Service Manual

CD Stereo System

Model No. **SA-AKX32PH**
SA-AKX32PN
SA-AKX32PR
SA-AKX52EB
SA-AKX52EG
SA-AKX52GN
SA-AKX52PH
SA-AKX52PN
SA-AKX72PH
SA-AKX72PN
SA-AKX92PH

Subject : Updates on Printed Circuit Board, Schematic Diagram, Exploded View,
Parts List & Troubleshooting Guide.

2.6. Jupiter Circuit (SA-AKX52EB/EG/GN-K)

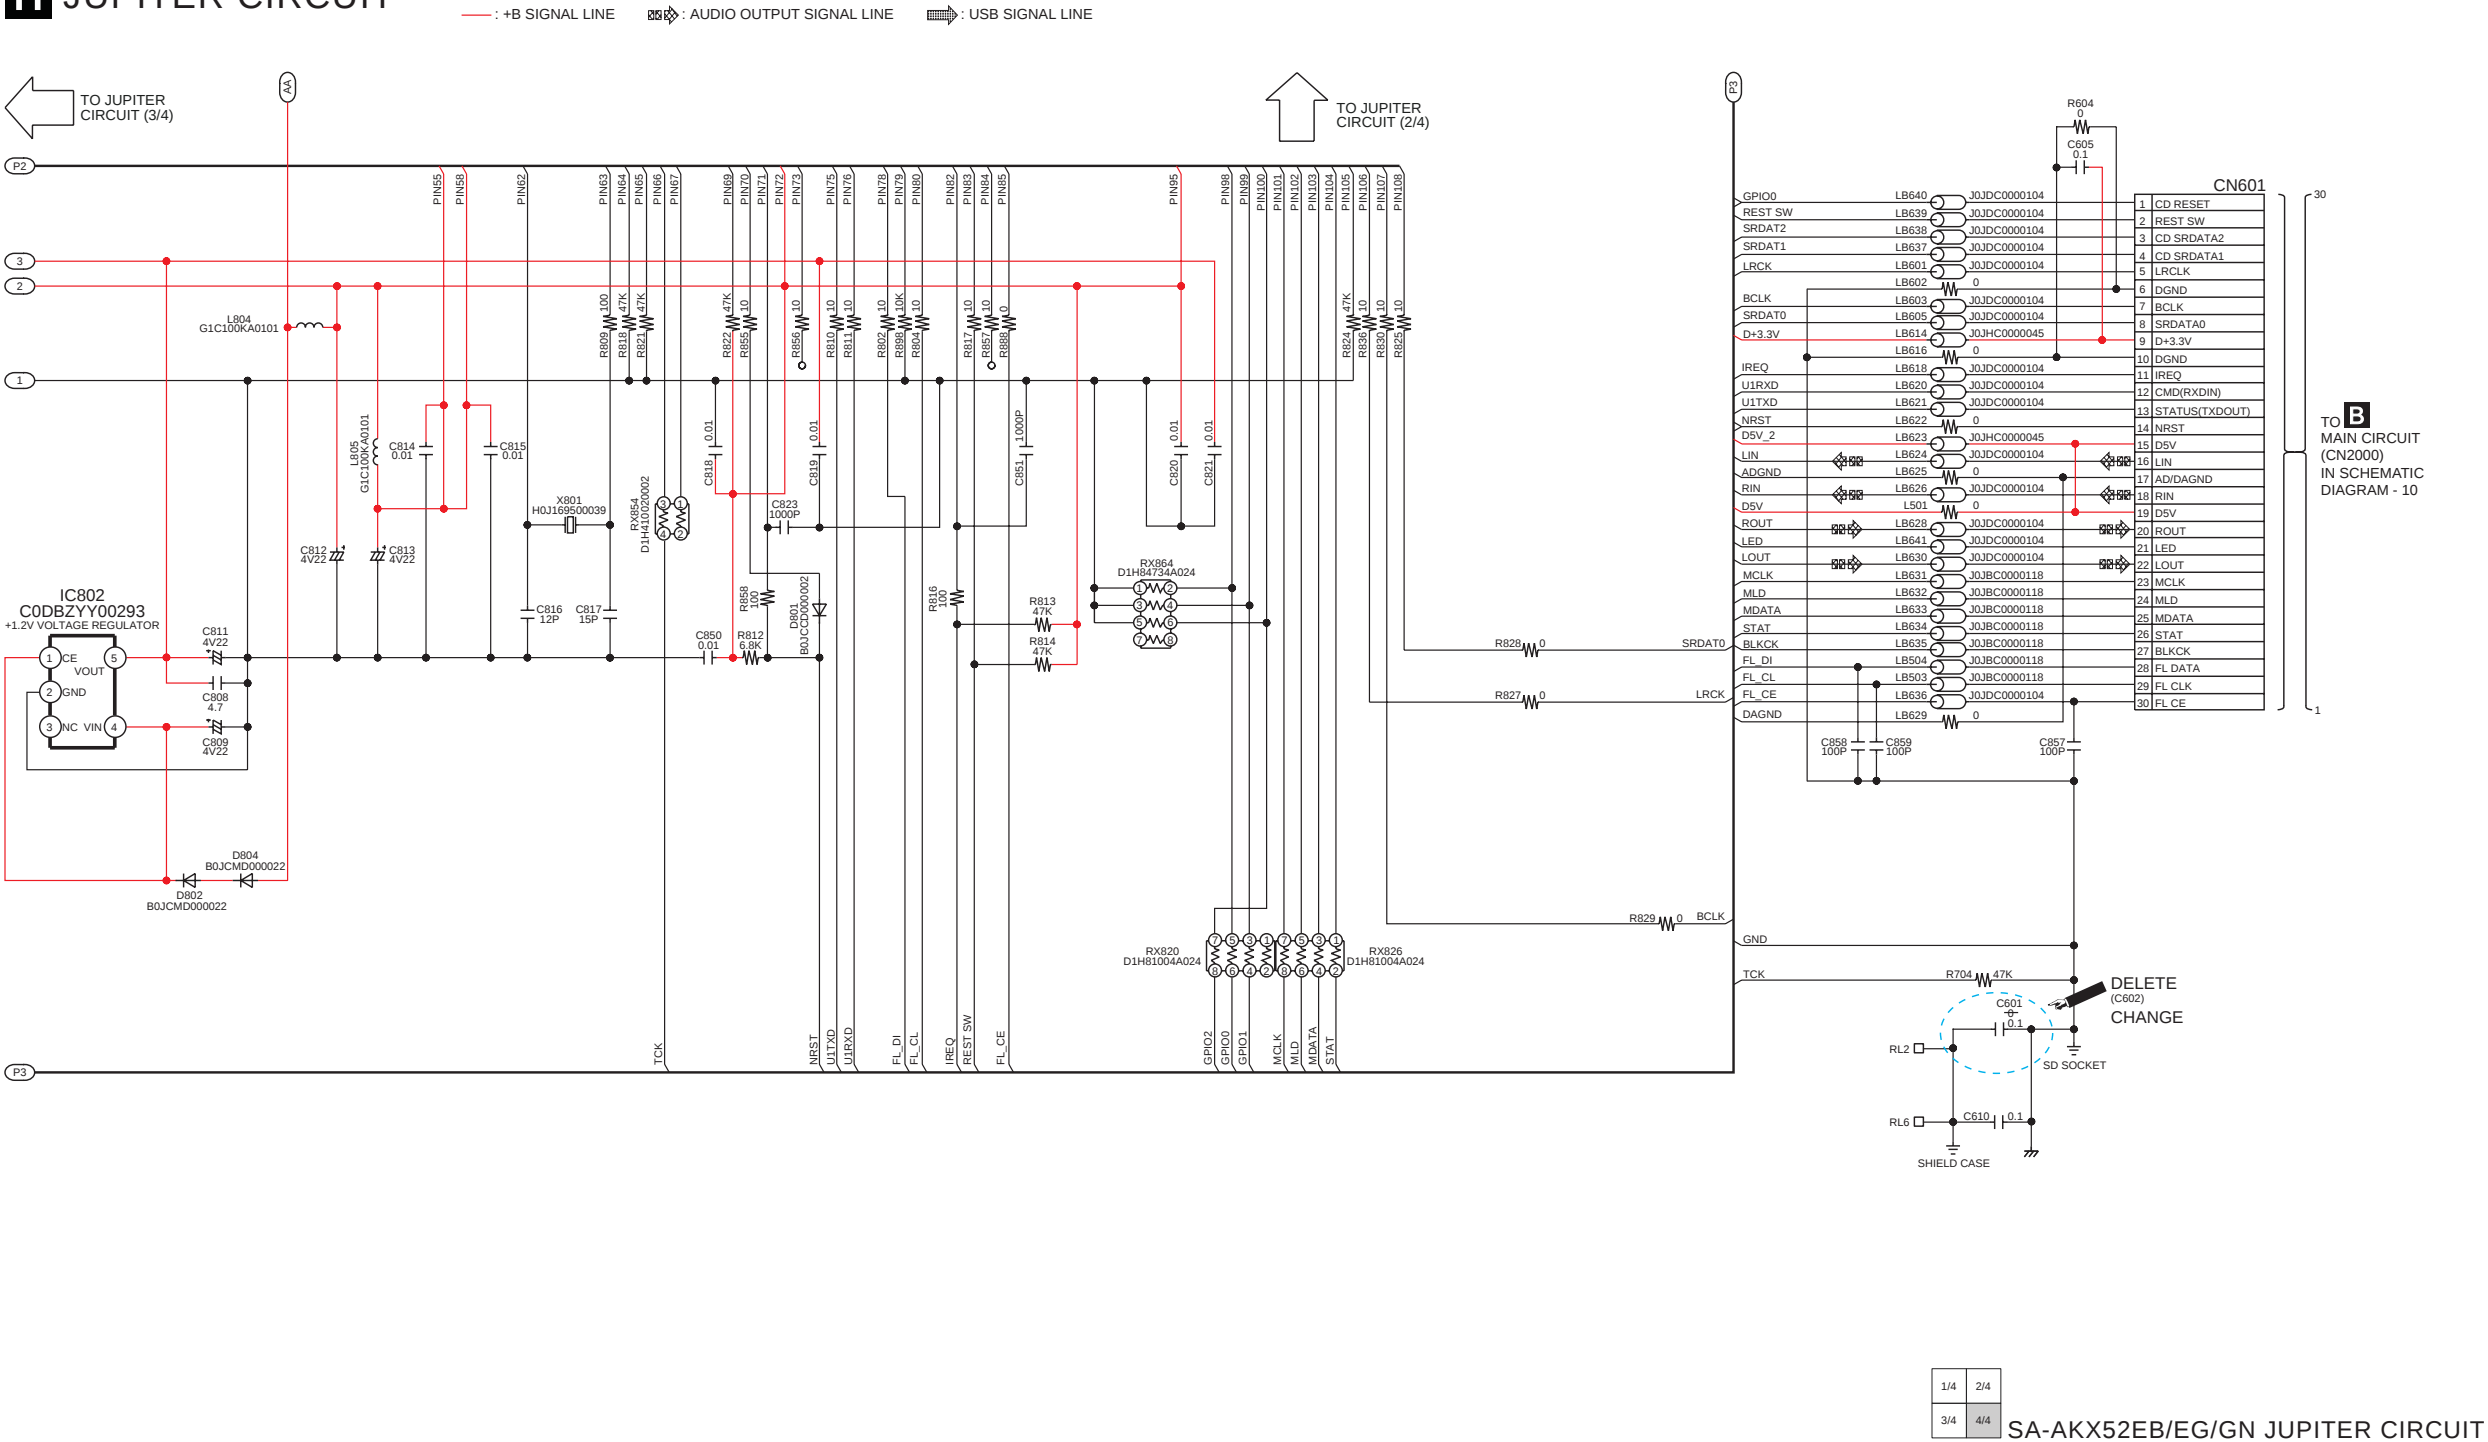
With reference to original service manual (section 17.7) on page 108.

2.7. Main Circuit (SA-AKX52PH/PN-K)

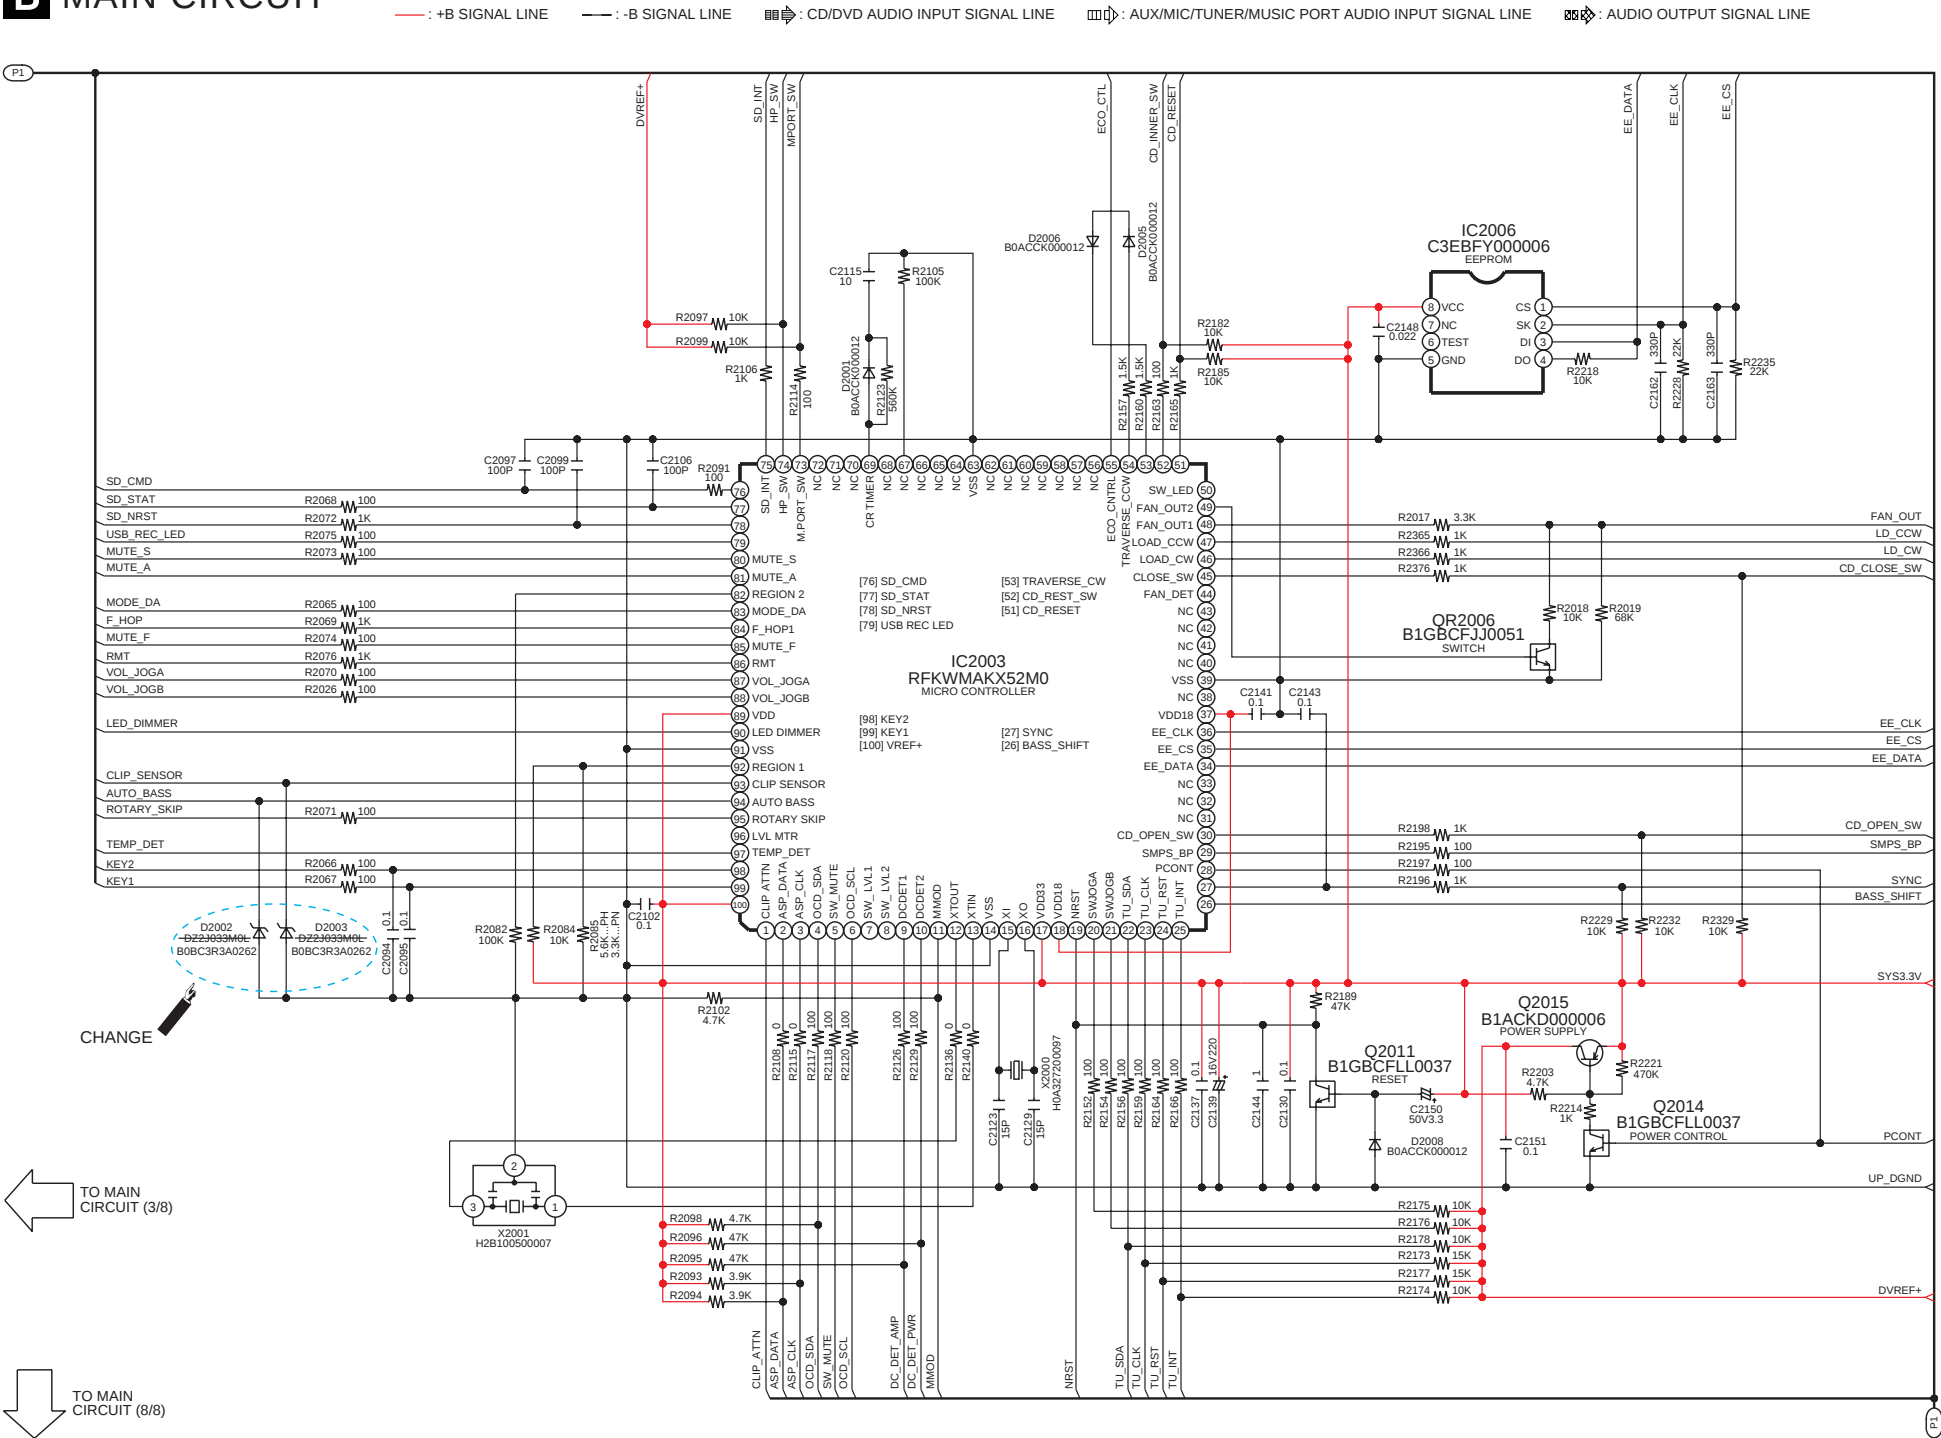
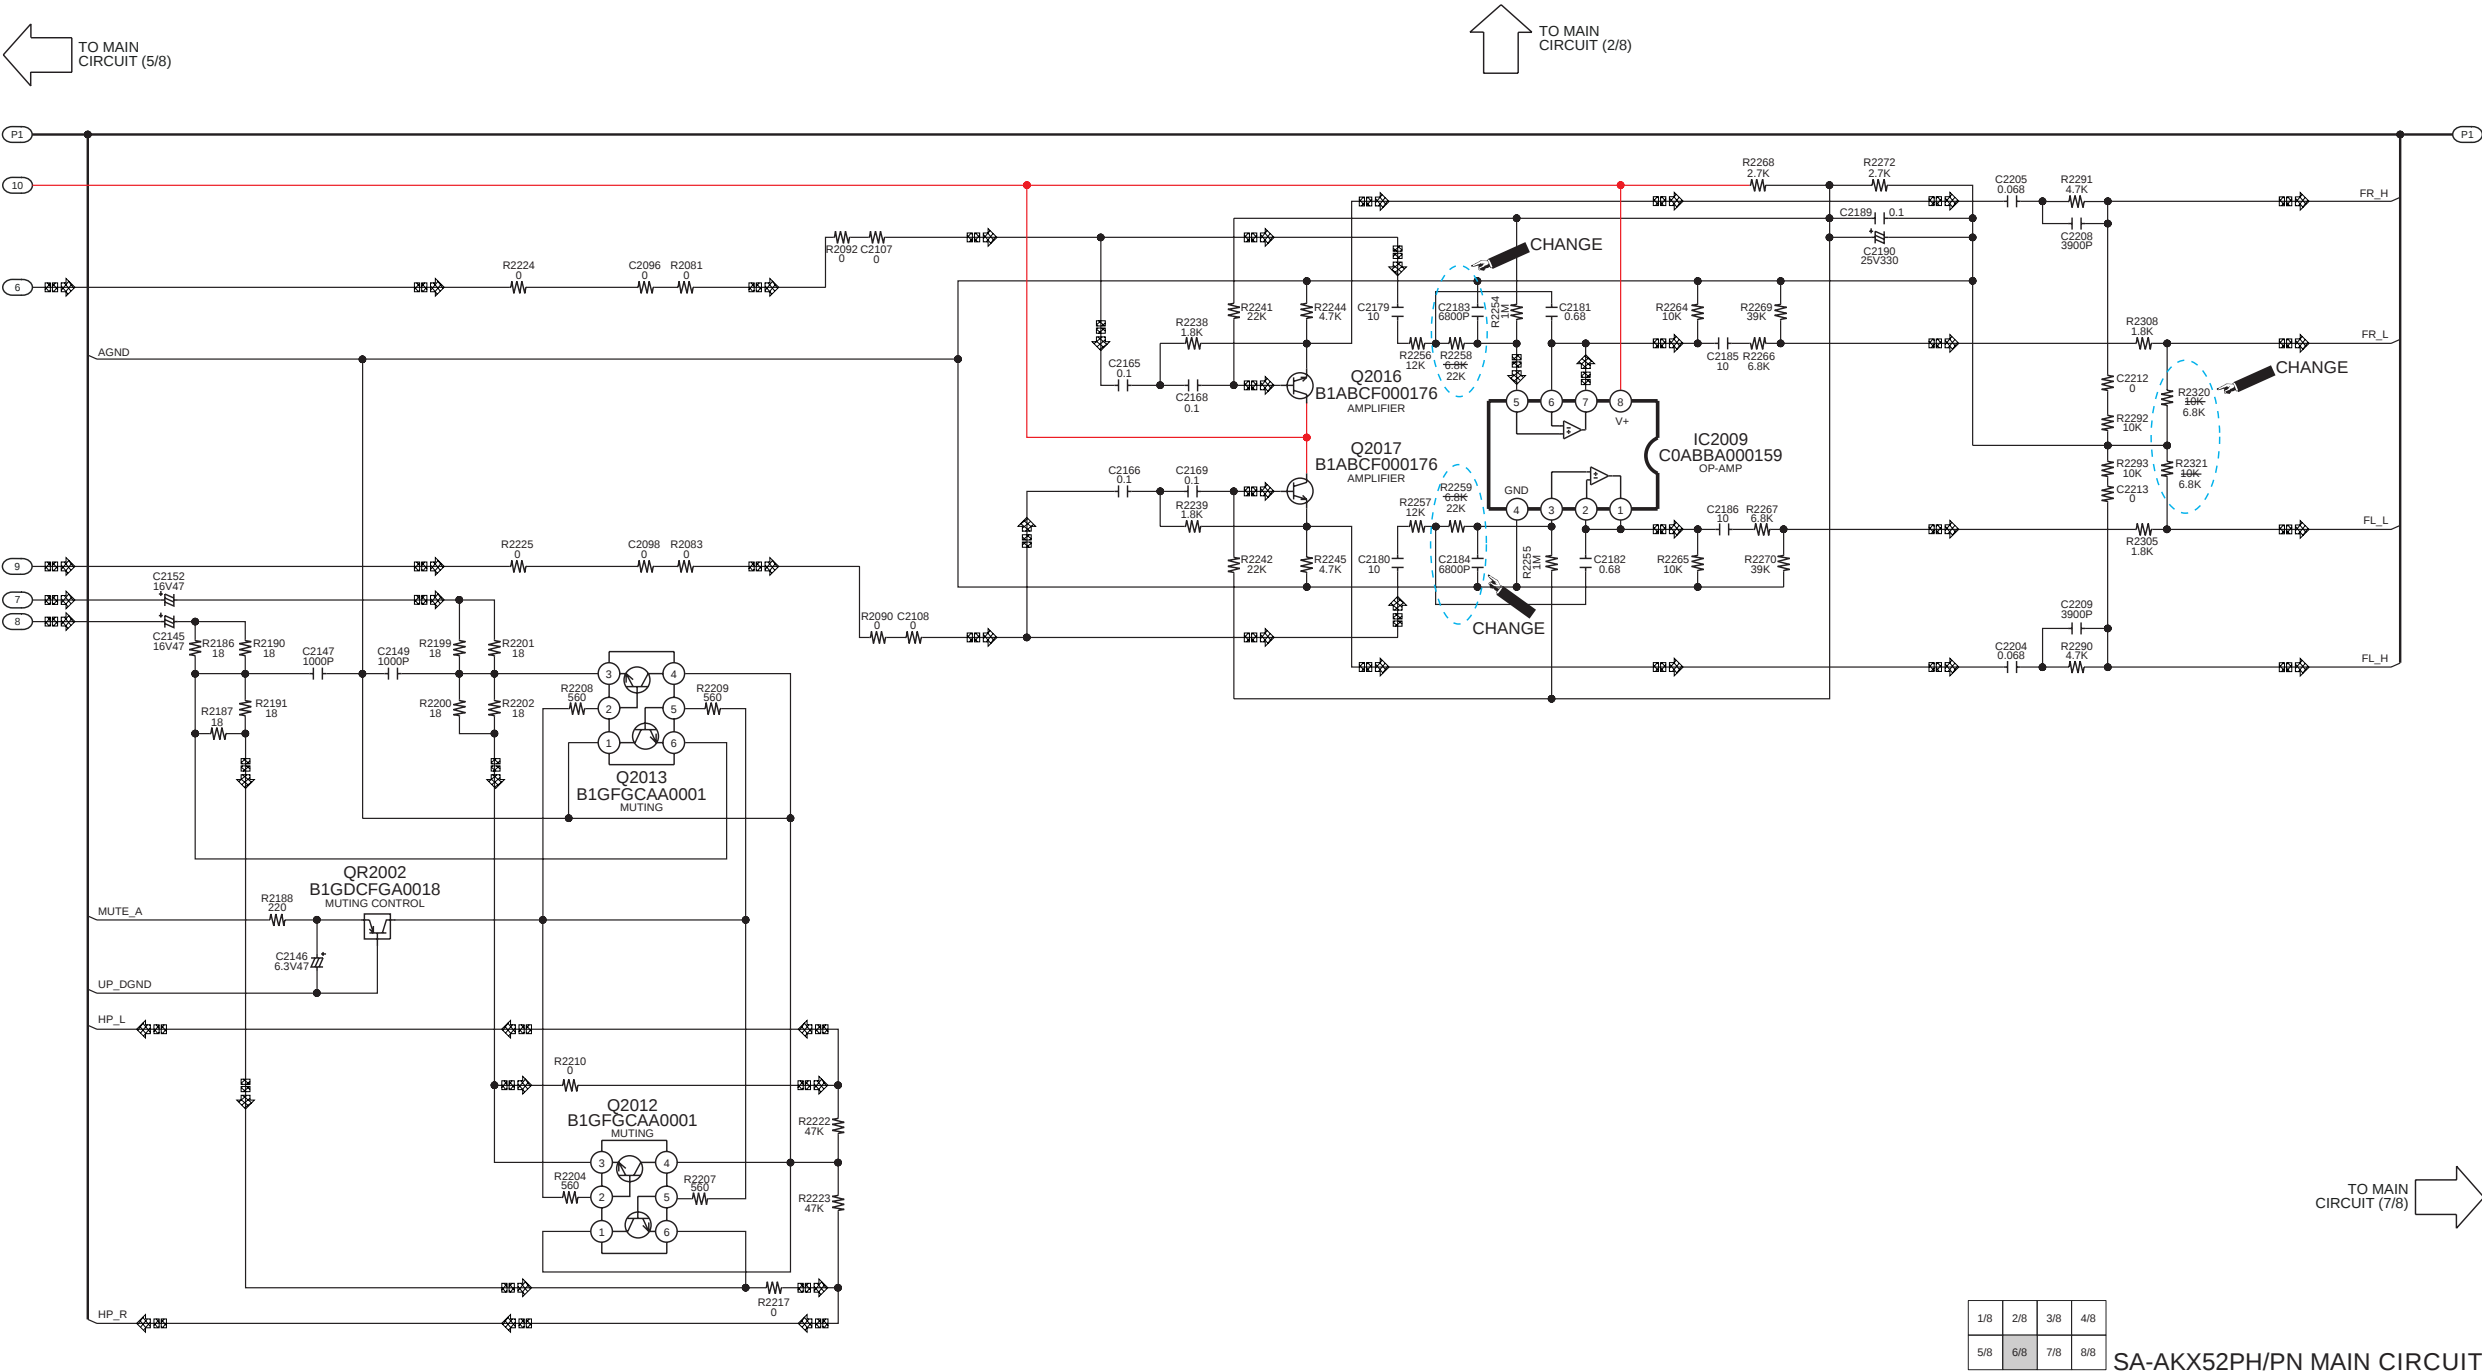
With reference to original service manual (section 17.3) on page 98, 99 & 100.

J SMPS P.C.B. (REPX0886J...PH)

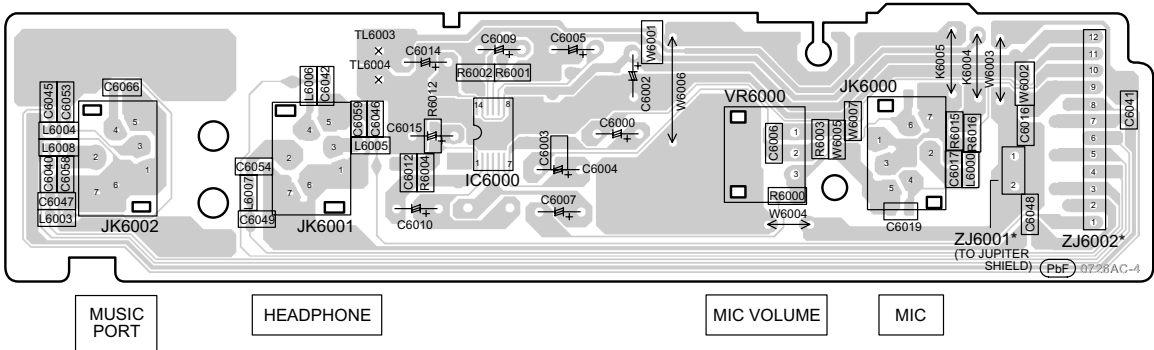
ADD
(TH5861)

ADD
(R5898)
ADD
(C5900)
